FINAL ADDENDUM 1

Offshore Sediment Study Work Plan at Oakland Inner Harbor, Pier Area, Todd Shipyard and Western Bayside

Alameda Point, Alameda, California

Response to Agency Comments on the Draft Addendum 1, Offshore Sediment Study Work Plan at Oakland Inner Harbor, Pier Area, Todd Shipyard and Western Bayside, Alameda Point, Alameda, California, dated August 25, 2006
Alameda Point, Alameda, California

Figure 3-6b. Proposed Sampling Locations

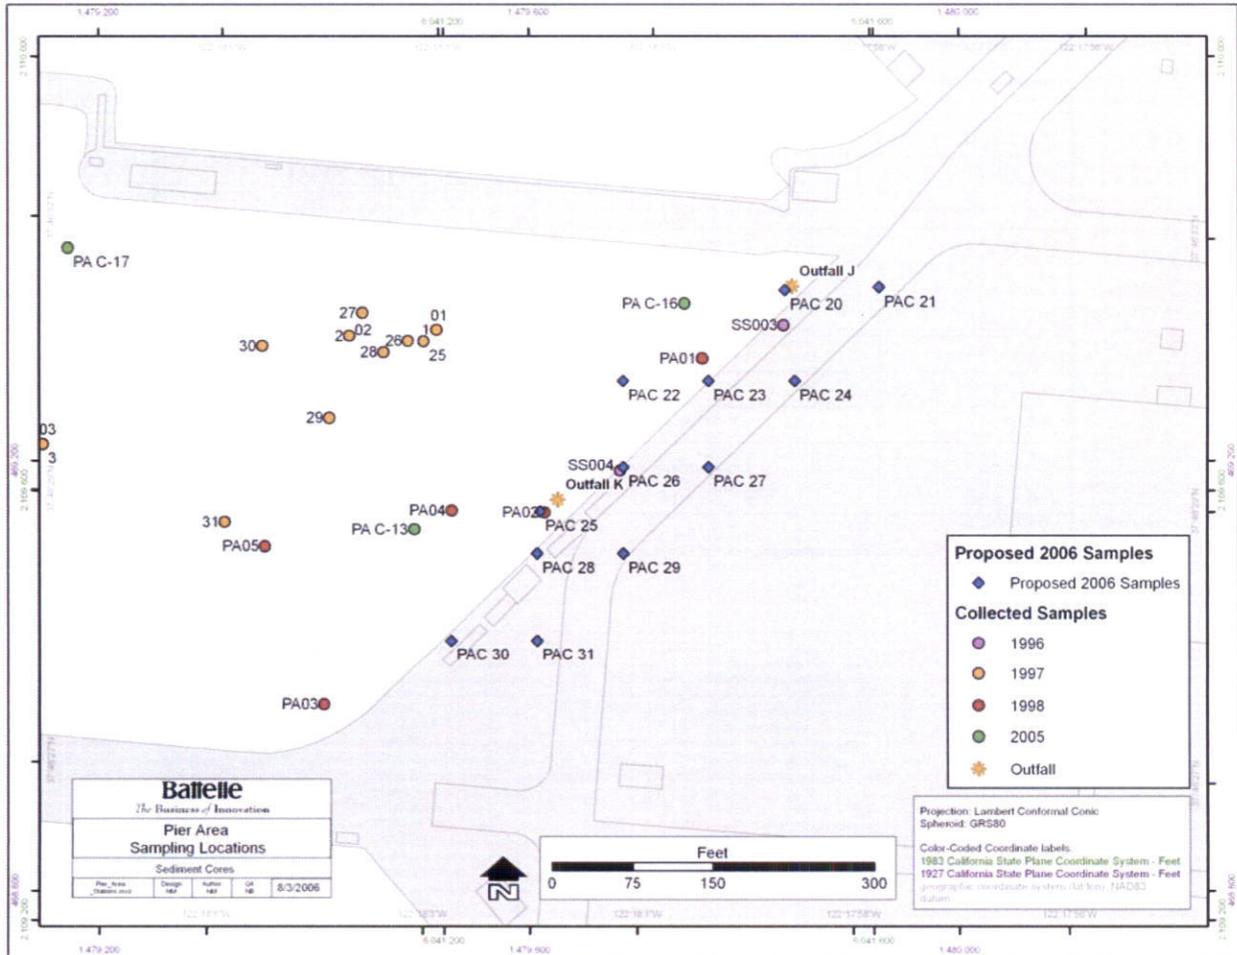
Work Plan Section	Original Work Plan Paragraph	Change	Rationale
	homogenized sediment samples will be shipped to the appropriate laboratory.		
p. 55, Figure 3-6	See attached Figure 3-6b.	Figure 3-6 should be changed to Figure 3-6a and Figure 3-6b should be added (Figure 3-6b is added in this Addendum).	Figure 3-6b shows the supplemental sampling stations at the Pier Area that are proposed in this Work Plan Addendum.
p. 56, Table 3-5	See attached Table 3-5b.	Table 3-5 should be changed to 3-5a and Table 3-5b should be added (Table 3-5b is added in this Addendum).	Table 3-5b lists the Latitudes and Longitudes of the supplemental sampling stations at the Pier Area that are proposed in this Work Plan Addendum.

Figure A-1a. Organizational Structure

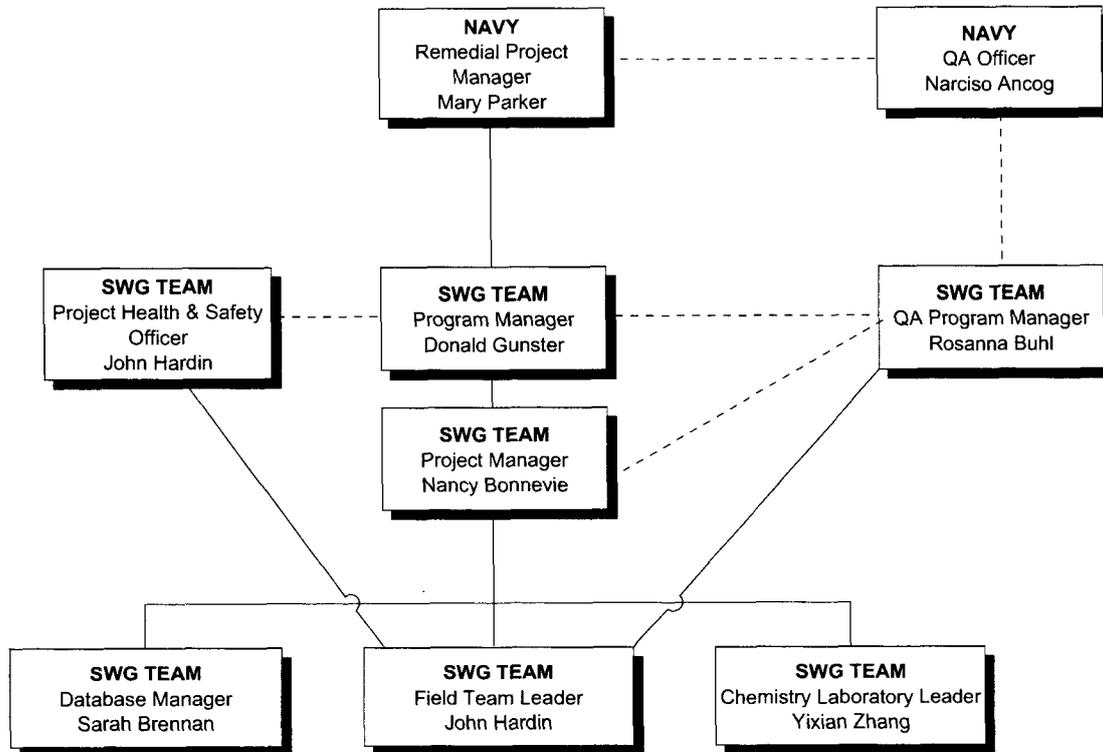
A.2.1 Project and Task Organization	Figure A-1 provides a project organization chart for the proposed Remedial Investigation (RI) activities at the offshore parcels. Table A-2 provides the responsibilities and authorities of key personnel for this project. (All tables are located at the end of this document). Key personnel shown in the chart and table include the Navy Remedial Project Manager (RPM), the Navy Quality Assurance Officer (QAO), the Battelle Program Manager, the Battelle Project Manager, the Battelle	Two personnel changes have occurred since the April 2005 SAP was approved. Navy Remedial Project Manager Darren Newton is replaced by Ms. Mary Parker. Chemistry Laboratory Leader Carole Peven-McCarthy is replaced by Ms. Yixian Zhang. Figure A-1a demonstrates the current Project Organizational Structure.	The new figure presents the current staff assignments.

Figure A-3a. Proposed Sampling Locations

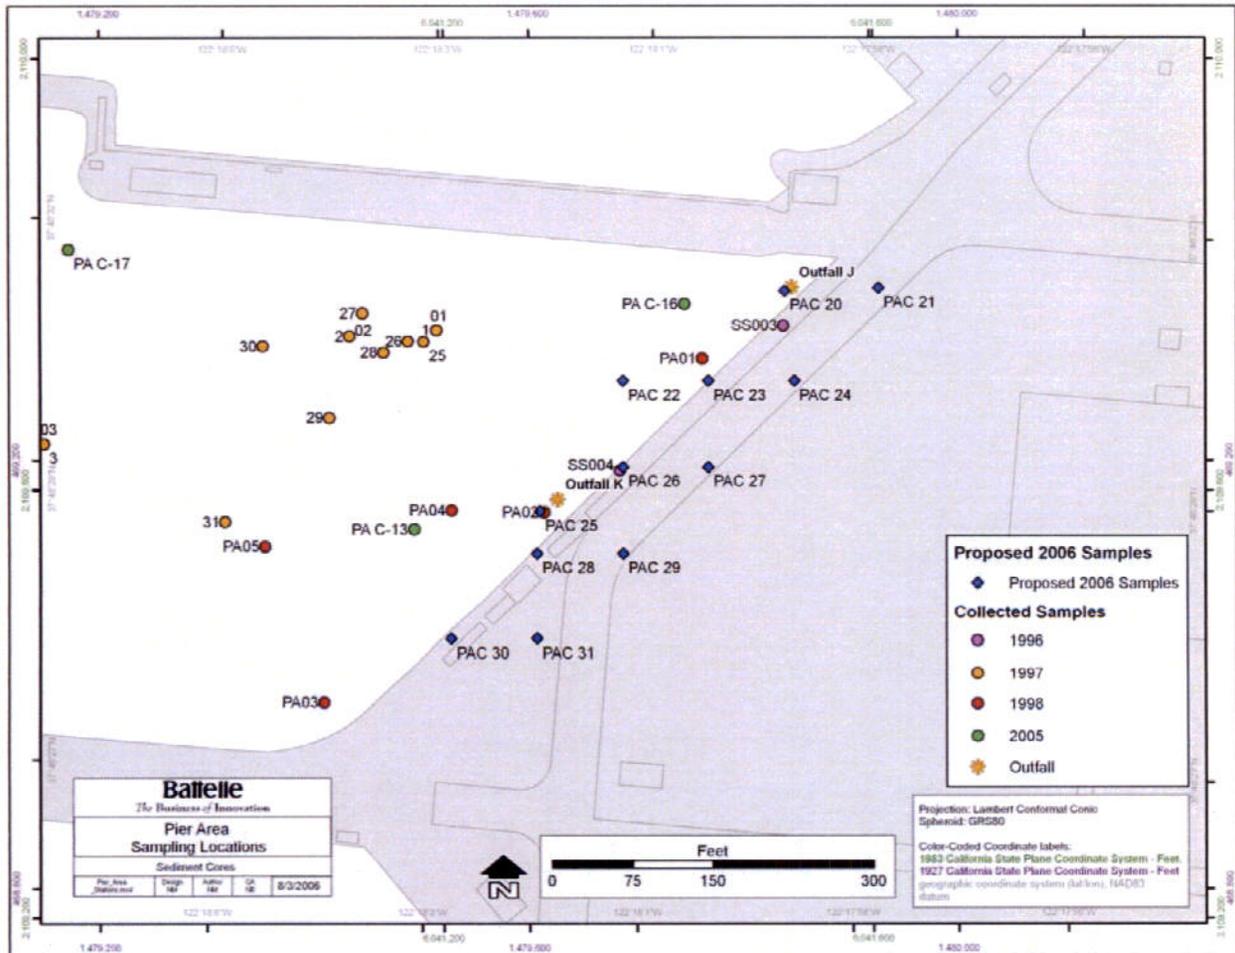
SAP Section	Text of Original SAP ¹ (April 2005)	Change	Rationale
	<p>to provide the ability to detect “hot spots”, and to provide samples that will determine if a COPC concentration gradient away from the quay wall is evident. Additional samples were added based on professional judgment to provide more extensive representation of the sediment shelf adjacent to the quay wall, where historically the highest levels of contaminants were measured.</p> <p>2. A total of 19 sediment cores are proposed as follows:</p> <ul style="list-style-type: none"> a. Four samples parallel and south of Pier 3 (PA C-1 through PA C-4), where historical data are basically lacking. b. Two samples along the shelf between Piers 2 and 3 (PA C-5 and 9), and three samples down the middle of the berthing area between the piers (PA C-6 to C-8) to provide representation of the sediment, and determine if there is a trend of decreasing concentrations away from the shelf. Sample PA C-5 will be taken adjacent to outfall L. Also, one sample (PB C-10) will be taken immediately adjacent to the south side of Pier 2. c. Two samples will be taken adjacent to outfalls K and J, respectively, on the shelf between Piers 1 and 2 where historically high levels of PAHs and metals were measured (PA C-13 and 16). In addition, two samples will be taken along the northern edge of Pier 2 (PA C-11 and 12), and two samples along the Pier 1 (PA C-17 and 18), Seaplane Lagoon breakwater boundary. PA C-19 will be taken to the east of Pier 3 on the boundary with Breakwater Beach. Finally, two samples will be taken in the berthing area to provide a gradient away from PA C-13 (PA C-14 and 15). <p>3. One sample will be taken from a reference area south of Pier 3 in the breakwater beach area to</p>	<p>(optimization) for the additional samples at Site 24 is as follows:</p> <p>A total of 12 sediment cores along the sediment shelf are proposed. The twelve sampling stations will be located within the area extending eastward past the quay wall beneath the roadway between Piers 1 and 2 (Figure A-3a).</p>	<p>locations should be incorporated into the table.</p>
